Redondo Beach Energy Project

(12-AFC-03)

Applicant's Comments on the Preliminary Staff Assessment

June 4, 2015

FIGURE PSA-VIS-1
Aesthetic Treatment Plan –
Conceptual Plan View
 AES Redondo Beach Energy Project – PSA Comments
 Redondo Beach, California

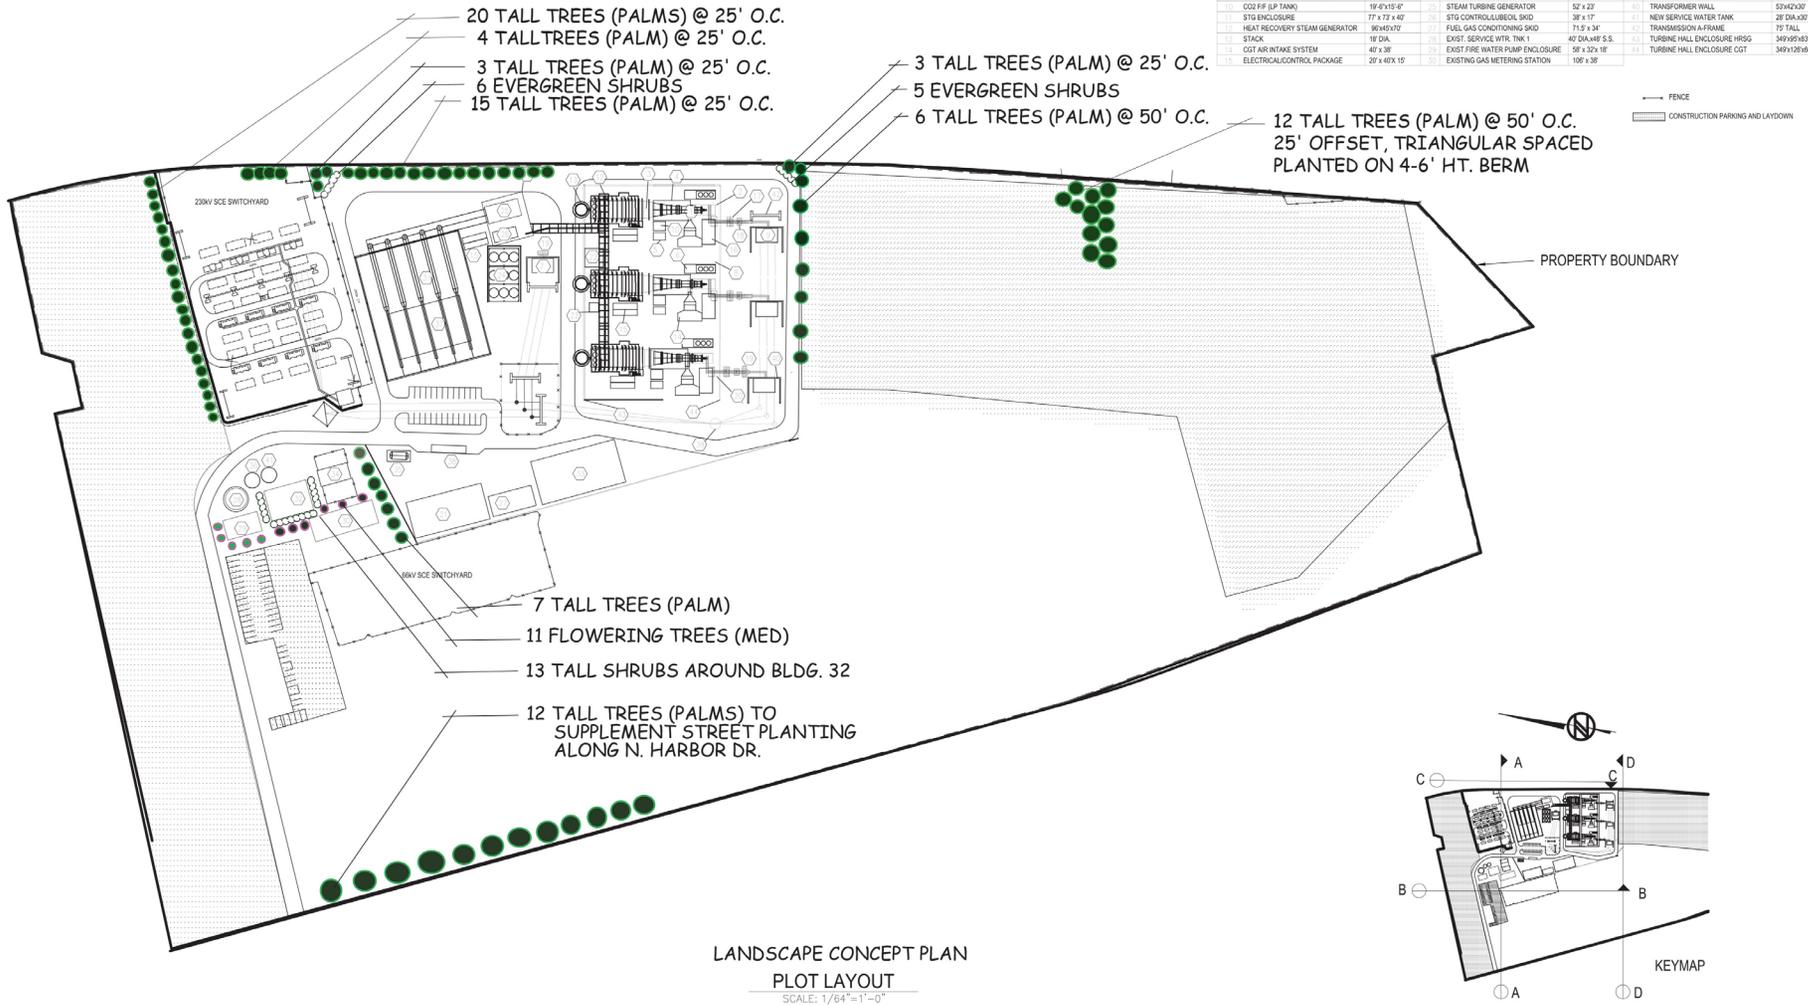
The PSA suggests the Applicant provide a revised Site Screening and Landscape Concept Plan and with a set of options from which additional plan components could be selected. While we disagree with the PSA's characterization of the degree of impact for some of the KOPs, we agree that additional landscaping and surface treatment would result in fewer visual effects from the project with regard to contrast, dominance, and overall visual change.

To that effect, a conceptual Aesthetic Treatment Plan for the project has been developed. This plan, which incorporates and replaces the proposed Landscape Concept Plan submitted with the AFC, takes guidance from the proposed Site Screening and Landscape Concept Plan referenced by the Commission staff and includes the following:

Figure PSA-VIS-1 shows the enhanced Aesthetic Treatment Plan. Figure PSA-VIS-2 shows the enhanced landscape concept on an aerial base.
